Subject: Liquefaction Analysis - Midland

SUBJECT: CORP OF ENGINEERS REPORT AND REQUEST FOR ADDITIONAL INFORMATION  
ON PLANT FILL

SUBJECT: Interagency Agreement No. NRC-03-79-167, Task No. 1 - Midland Plant  
Units 1 and 2, Subtask No. 1 - Letter Report

SUBJECT: Effect of Plant Fill on Seismic Ground Motion Environment at the  
Midland Michigan Nuclear Power Plant

Figure 5.

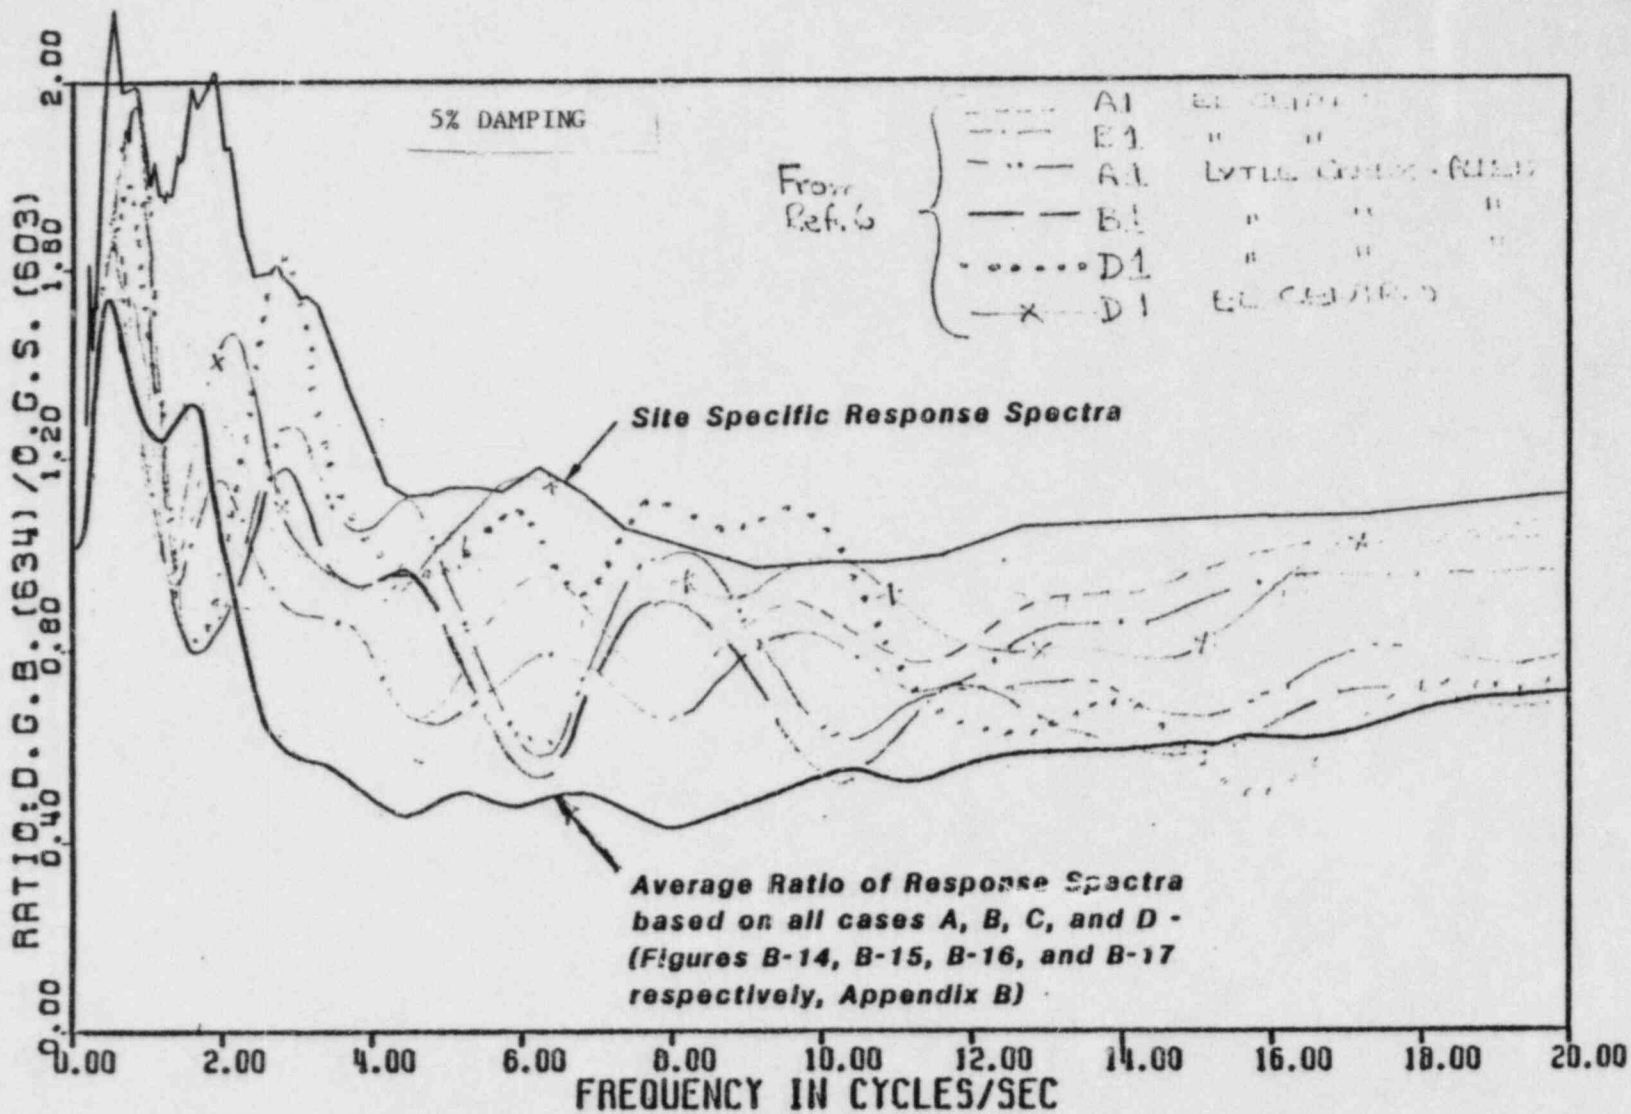
9. In the final analysis, all of the work in Appendix B of Reference 3 is summarized in a plot of the ratio of response spectra for the top fill to that for the original ground surface. See Figure 5, which is a copy of Figure 9 of Reference 3. The fact that the analytically developed curve (a) lies below the curve for the comparable ratio of empirically developed site specific response spectra (SSRS) and, (b) has a similar shape been used as an argument that the empirically based SSRS are physically reasonable and are more conservative than the top of fill spectrum that would have been obtained via a SHAKE code calculation. The additional ratio of response spectra calculations furnished in Reference 6 are superimposed on Figure 5 and show that the effect of revising the site properties was to increase the calculated ratios of response spectra (RRS) in the 1/2 to 10Hz range. However, the analytically developed RRS still (with minor exception) lie below the RRS for the empirically developed site specific response spectra.

FIG. 6 84<sup>TH</sup> PERCENTILE SPECTRA FROM REFERENCES 3 AND 5

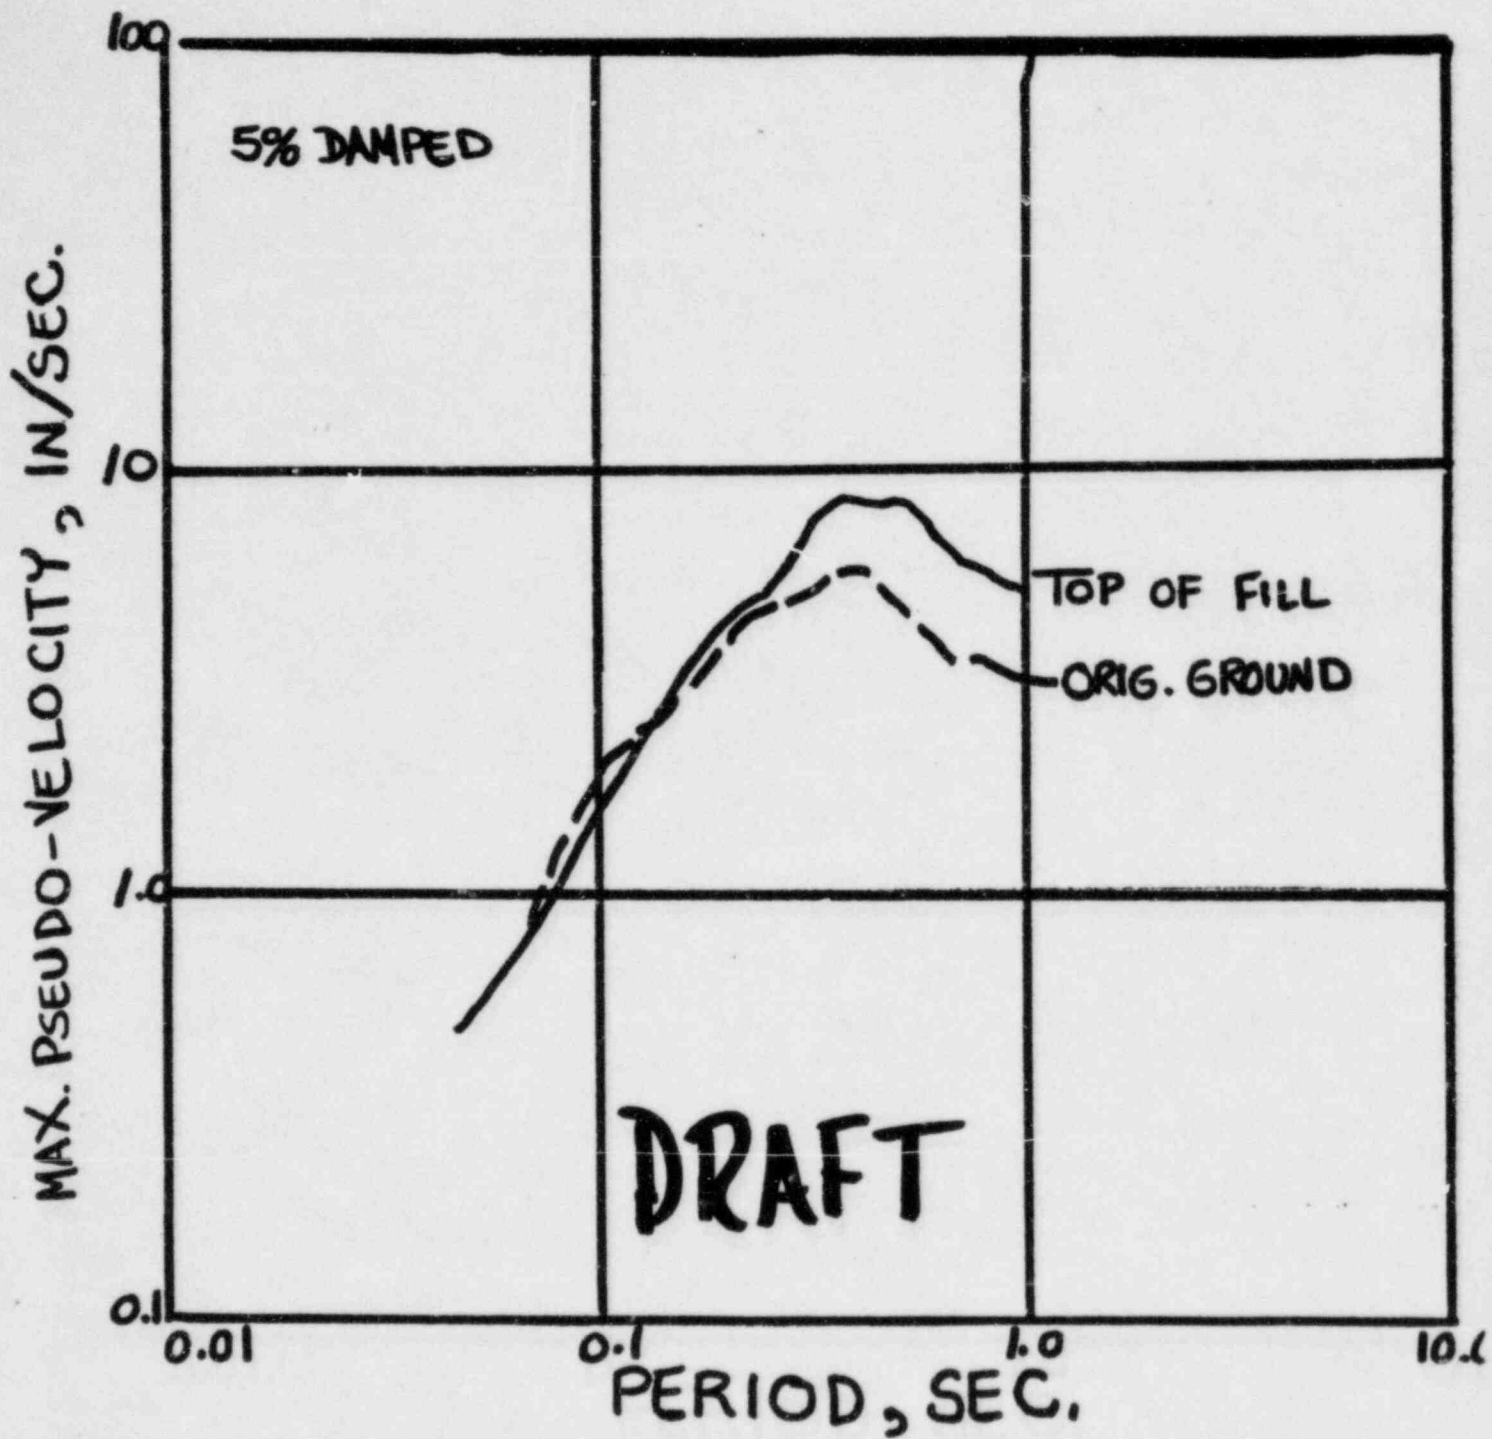
10. Figure 6 shows the 84th percentile, 5 percent damped site specific response spectra developed via empirical methods in References 3 and 5 for the top of plant fill and the original ground surface, respectively. Figure 6 indicates that the empirical approach produces substantial amplification of response at periods greater than 0.25 sec (frequencies less than 4 hz), which is supported by the additional calculations reported in Reference 6 and displayed in Figure 5.

Figure 7. Comparison of Amplification Curves Obtained Using the El Centro Record

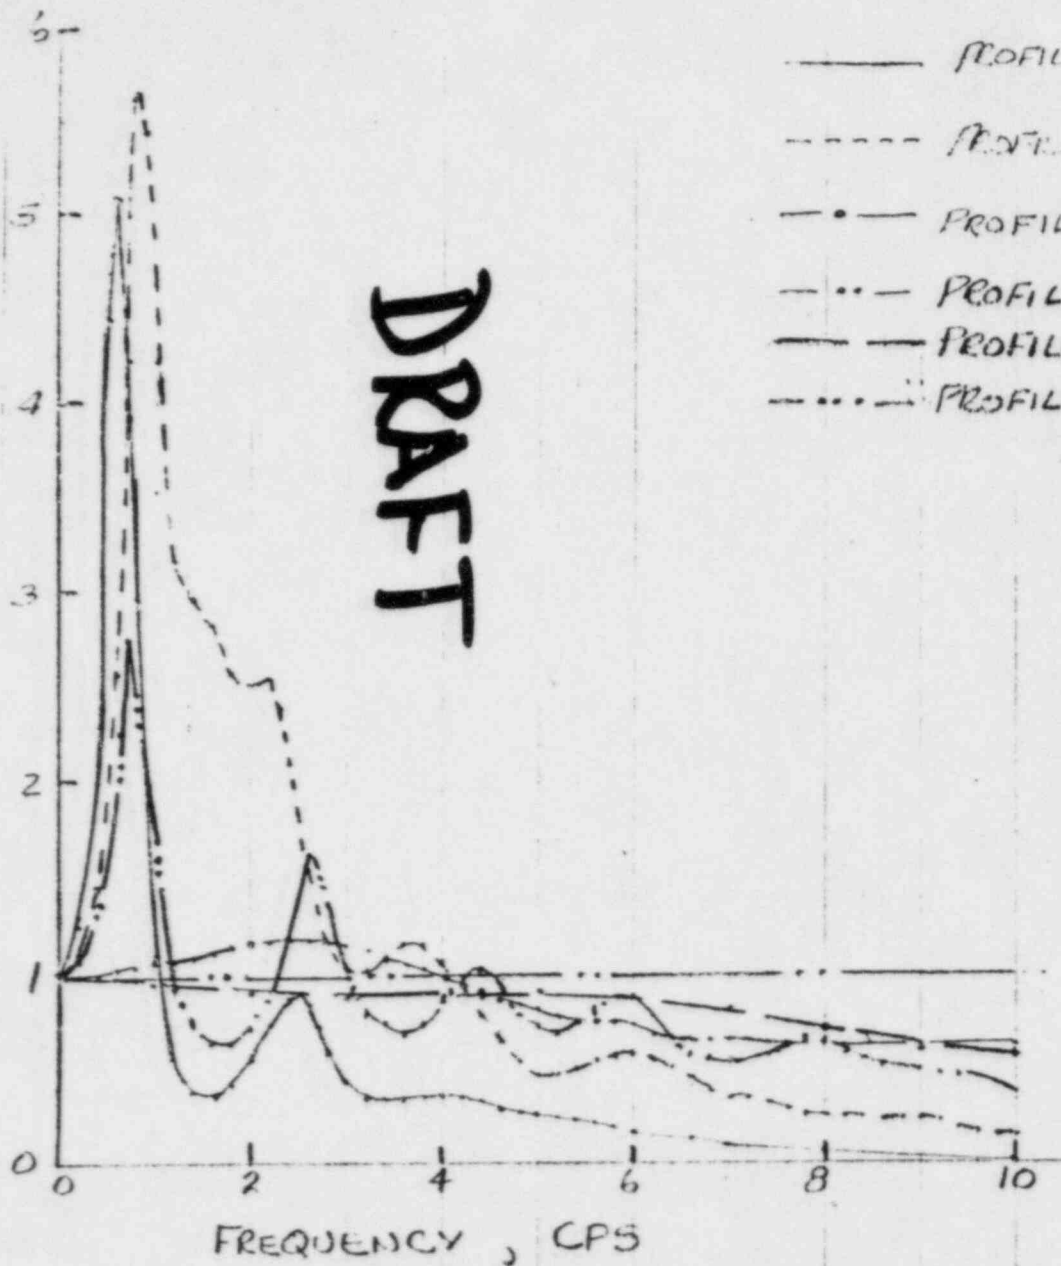
13. Figure 7 shows the effect of some variation in site profile on the amplification factor curve for the motion at the top of fill with respect to outcrop motion. Figure 8 shows the effects of the same variations in site profile on 5 percent damped shock spectra at the ground surface. Profile F, whose properties are given in Table 4 and whose low strain level shear modulus vs depth relationship is given by the solid line in Figure 1 represents this writer's judgment of the lower limit of fill stiffness and the best estimate of the stiffness of the natural ground. Profile G, whose properties are given in Table 5, represents this writer's judgment on the upper limit of the fill stiffness. Below the plant fill it is the same as F. Profile H (see Table 6) is the same site profile as F and G, but with the fill removed. The top of the profile in this case is the original ground surface. Case I is the same as A but with the fill removed.

14. Figures 7 and 8 show that changing profiles make substantial differences in the results of the calculations. The effects are best shown on the shock spectra in Figure 8. When profiles A and I are compared (wrong site properties with and without fill) it is seen that the effect is also deamplification at frequencies above 1 Hz but to a lesser degree. Figure 7 shows that in the lower frequency range (below 1 Hz) the effect of the presence of the fill (either Case A or F) is substantial amplification over Case I.

15. Figure 7 also shows for Profile F what happens when the outcrop location is changed to the top of till (i.e. the original ground surface), a location considered more realistic for a ground motion record recorded on the surface of

Figure 8. Shock Spectra for Top of the Site Profile, Fill Vs No Fill and for Variations in Site Profile

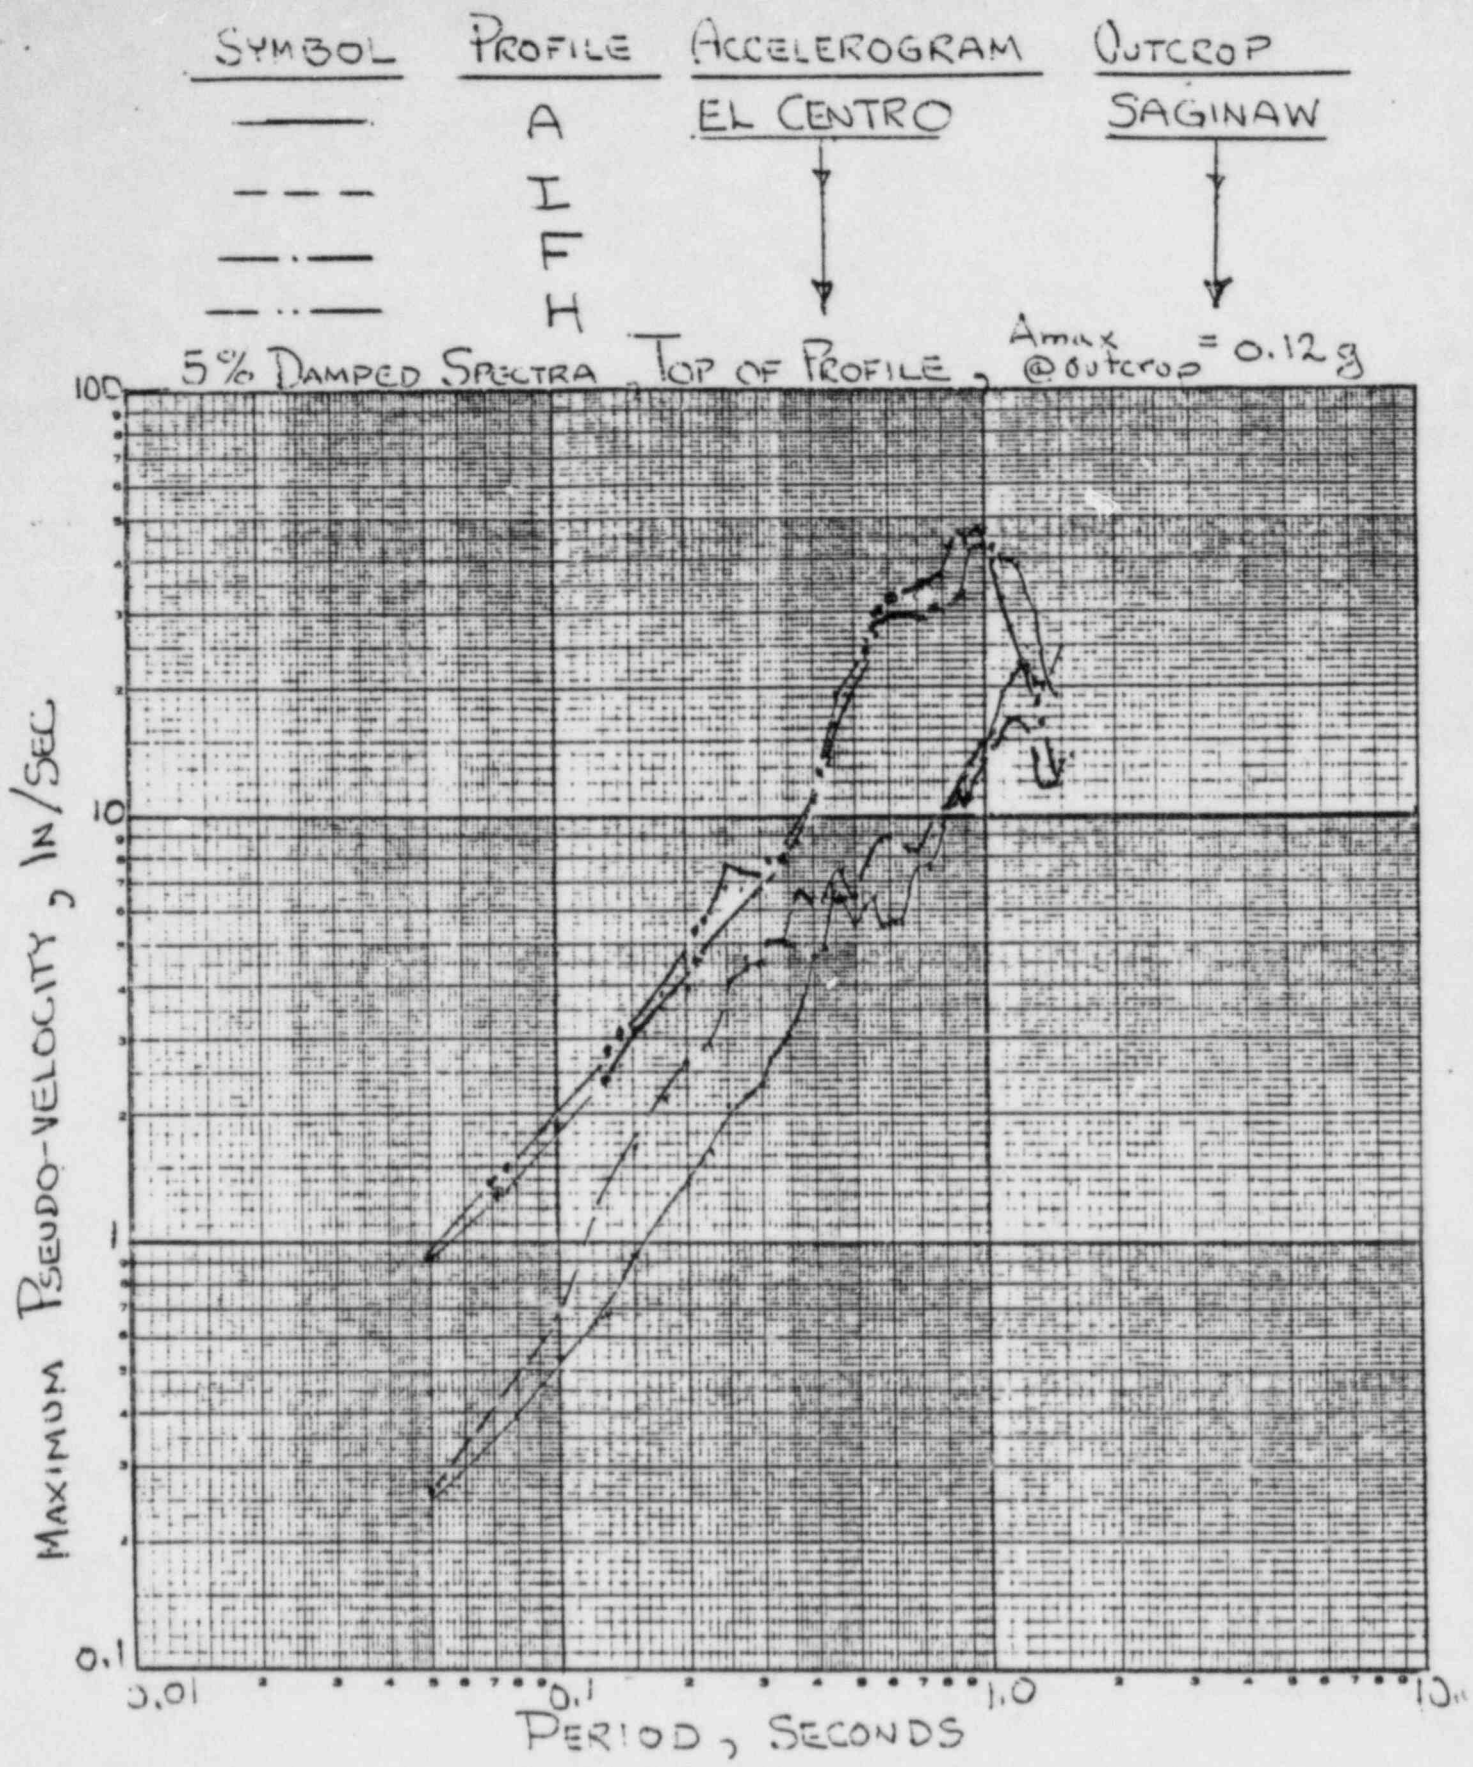
16. While this writer considers the spectra in Figure 8 for the A and I profiles inappropriate because of the bedrock outcrop location used in the calculation and the size of earthquake in which the record was obtained, the spectra in Figure 8 can be compared with the 84th percentile empirically developed spectra shown in Figure 6 by overlaying the transparency of Figure 6 given at the end of this report on Figure 8. In fact, the same comparison can be made with any of the spectra which follow.

Figure 9. Shock Spectra for Profiles F, G, and H Using the El Centro Record as a Till Outcrop

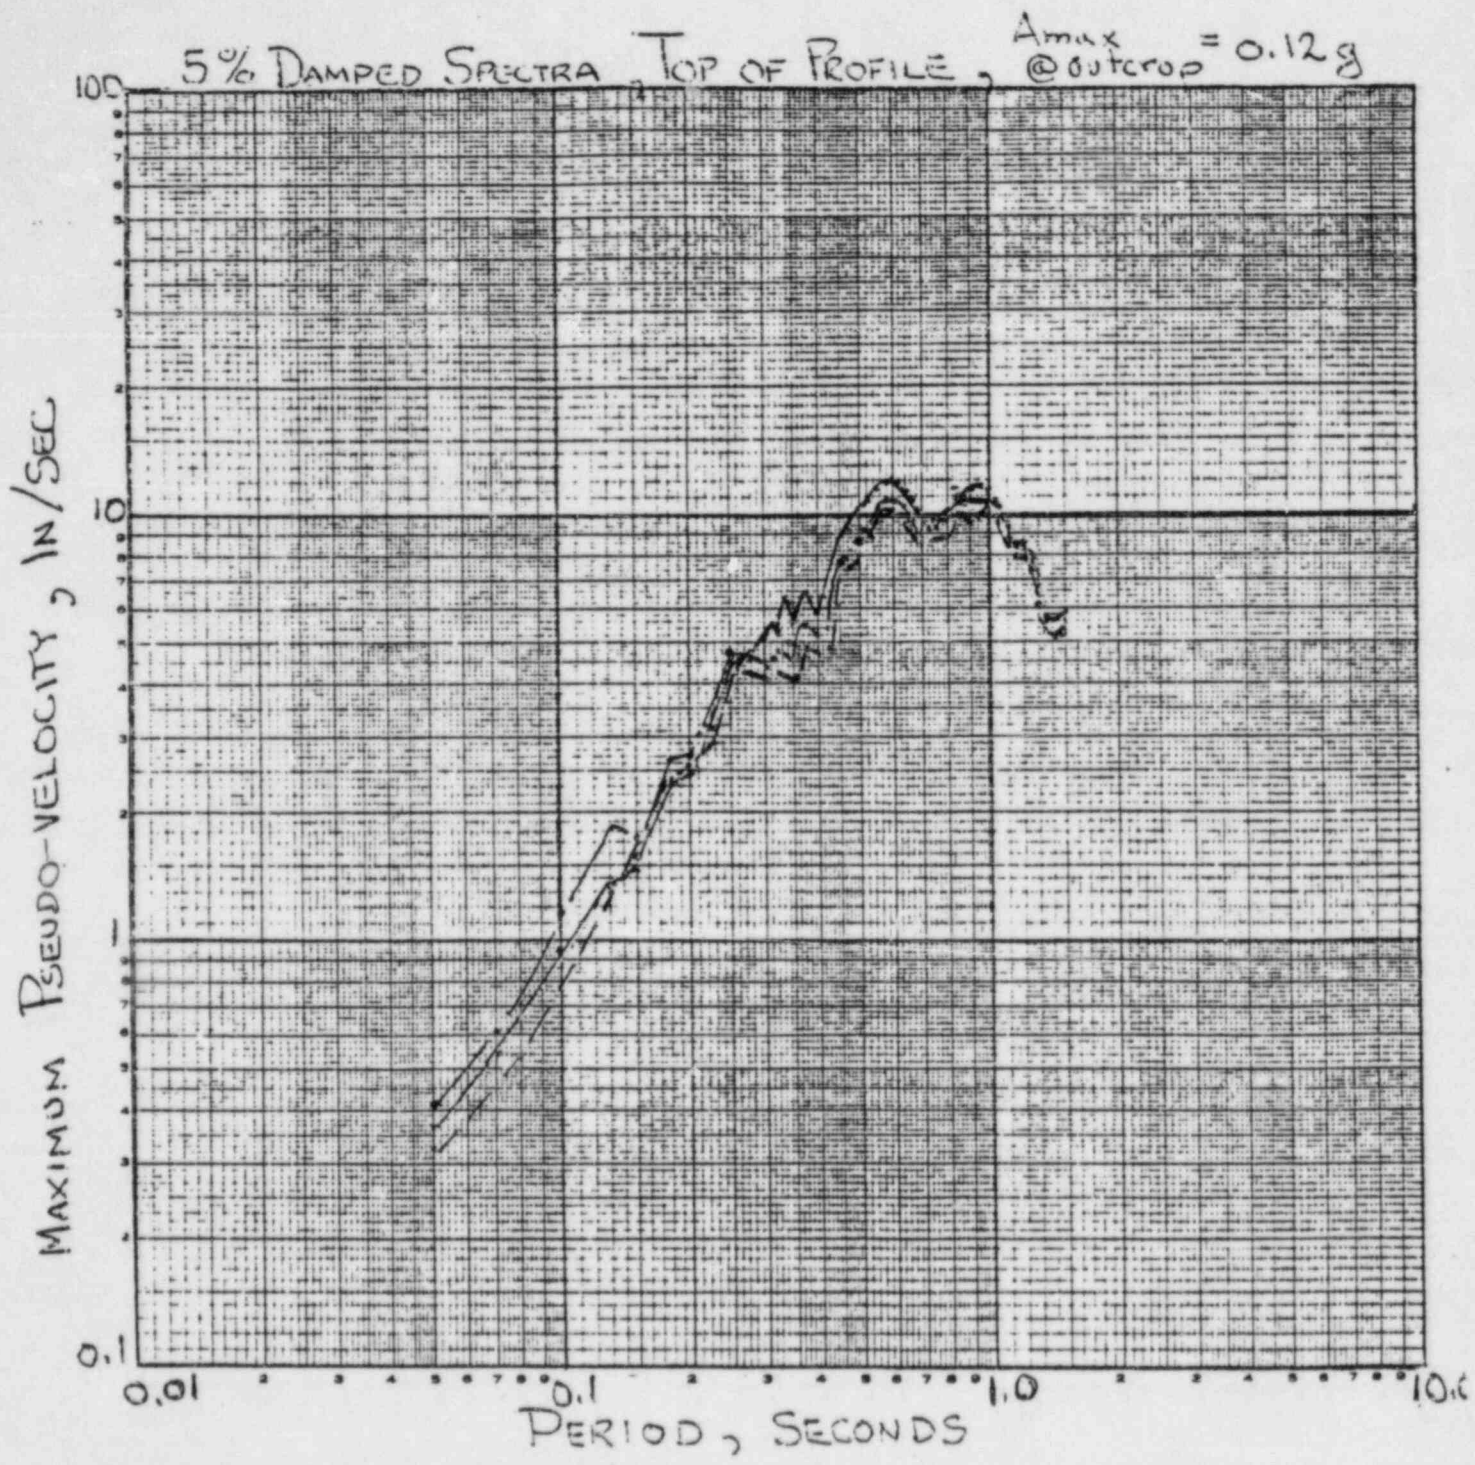
17. Figure 9 shows the spectra for the top of the F, G, and H profiles calculated if the El Centro record is used as a till outcrop which is physically more realistic than using it as a rock outcrop record. In the 1 to 5 Hz frequency range, the Profile G spectra is almost the same as that for the original ground surface while the spectra for Profile F shows modest amplification. While the El Centro record is from an earthquake of larger magnitude than the safe shutdown earthquake, it is still of interest to compare Figure 9 with Figure 6. All three spectra exceed the empirical one for the top of fill at frequencies below 2 Hz.
